PROJECT NO. 30-78316-1102
PROJECT: Timber Valley
DATE: August 7, 1979

REFERENCE: Drainage Concept

Subject: Timber Valley Addn.

Re: S/D 79-80 Preliminary plat of Timber Valley

Timber Valley Addition Drainage Concept:

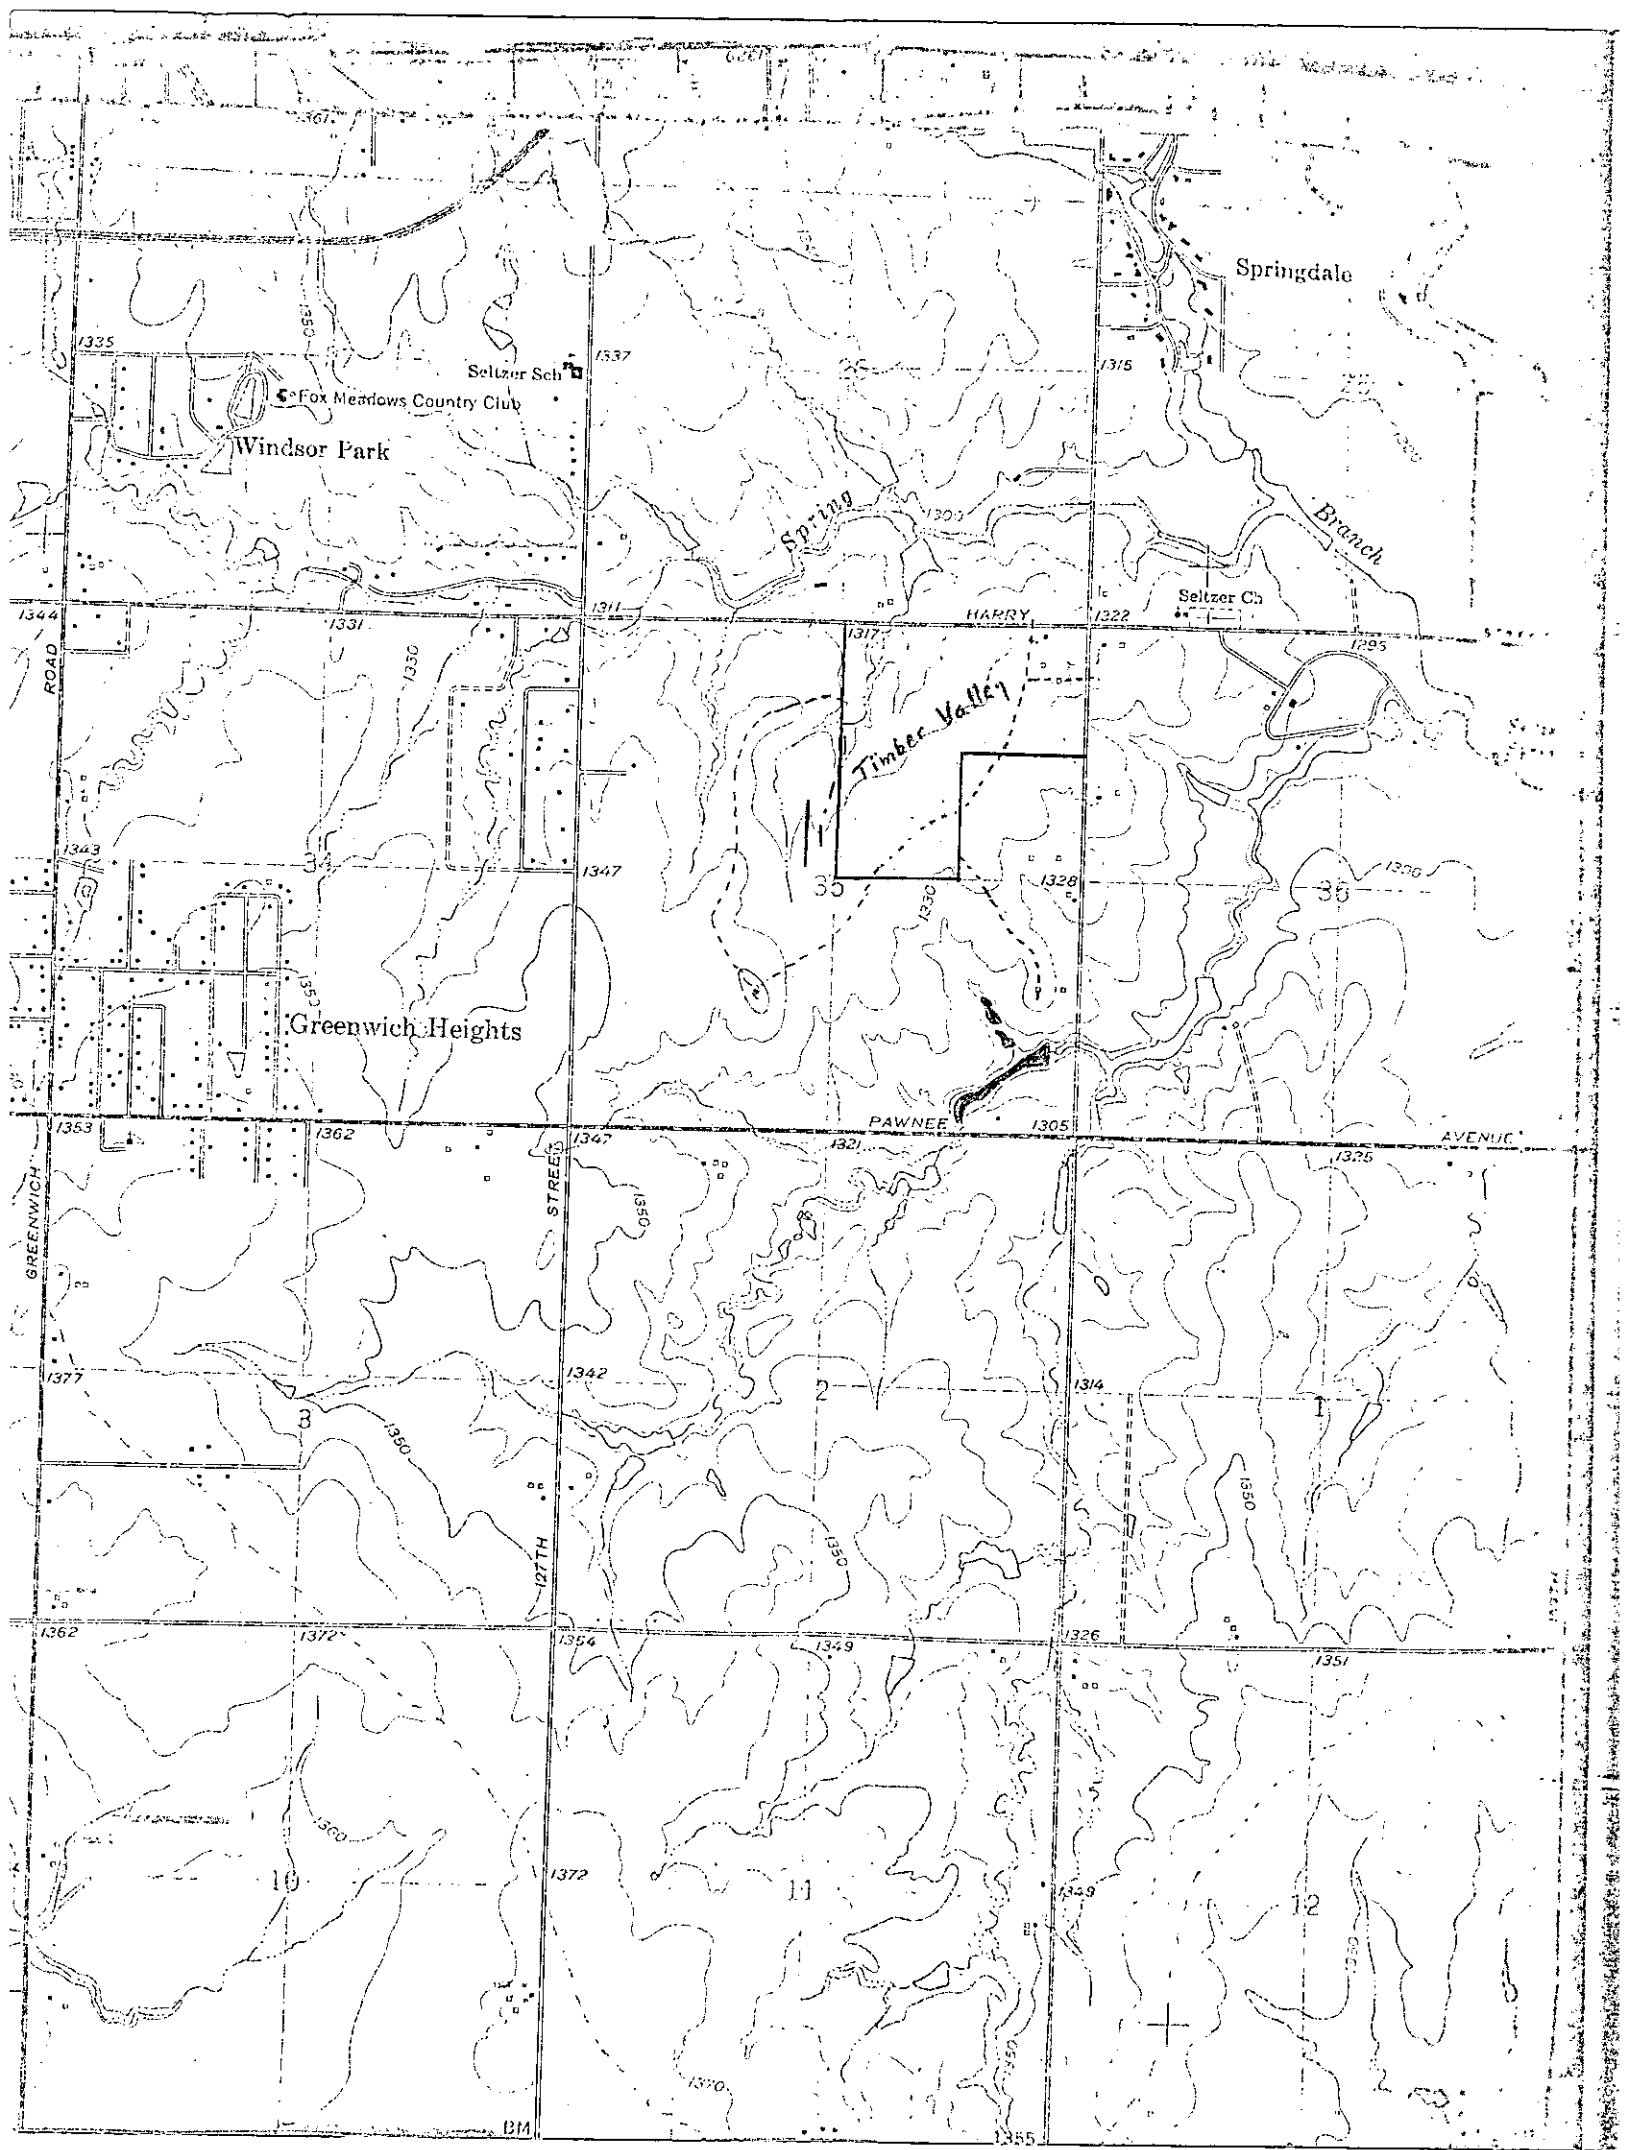
Area of Question: Revised Drainage Concept dated 8/22/79

1. Culverts and Drainage @ 143rd St. East & Harry.
2. General Plan of Drainage Dedication required south of Brook F St. Drive
3. Is Ex. 18'x22' CMP under 143rd St. East adequate?
4. Are both sets of 2-58"x36"x36' CMP under Harry adequate for drainage as planned for drainage concept. What about downstreams?

Typ. X-section
for 58' Right-of-Way

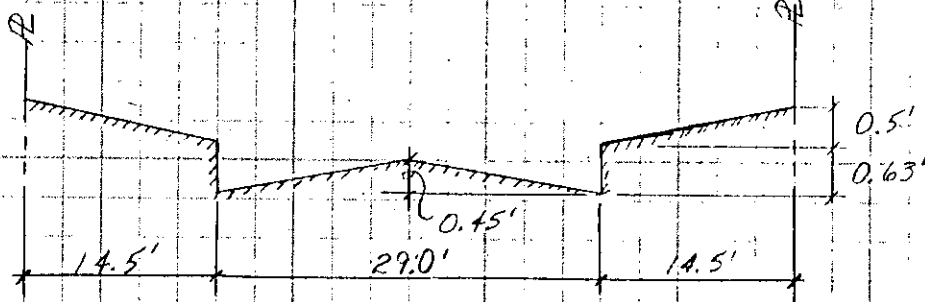
Should use a lower roughness coeff. N
